Subject: Technical Team Meeting #9

Client: CDOT Region 1

Project: I-70 Peak Period Shoulder Lane

Meeting Date: January 27, 2014

13. PROPOSED SIGNAGE

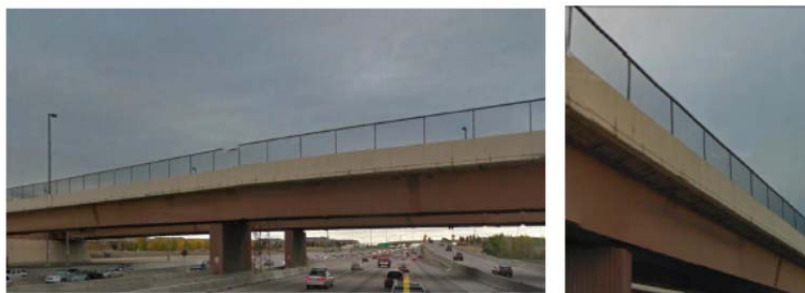
- a. Express Lane Entrance (*2 mile warning sign*)
- b. Express Lane Toll Sign—has a camera pole next to the sign, where it visually appears to be one structure.
- c. Express Lane Entrance (*1 mile warning sign*)

- d. Express Lane Entrance (*1/2 mile warning sign*)—consolidate the new sign, variable speed limit sign (scrolling signs to the different speed limits)

- e. Express Lane Entrance
- f. Express Lane Toll Sign—want to give people on the mainline a second chance to see the price in case they missed the first sign.

- g. Express Lane Only Sign (regulatory sign)—Looks more like a shoulder during off-peak. On 24/7. Red X during an emergency.
- h. ATM Signs
 - i. *West of Lawson*—same size sign (X), but could be a smaller sign or on the side; have some flexibility with this one. It was placed here because of the curve, and the spacing.

- ii. *East of Lawson*—can we use a smaller sign? Yes, that is possible because the first 7 signs were medium. If an X is all that it will hold, then a small one would work. Spacing it with a larger sign makes sense.

- vi. ATM Sign (Sta. 576+00)—could be a smaller sign.
 - vii. ATM Sign (Sta. 631+00)—large sign
- i. We got some good ideas. A lot of work to be done to rework this and move signs and reduce size of some signs.

- j. We reduced 2/3 of the signs to small from medium, even though the number of signs are pretty much the same.
- k. Will go back and look at it and look at where the crashes are to make sure we are not taking out a sign in the vicinity of that. Will modify our sign table and email the table back to the group.
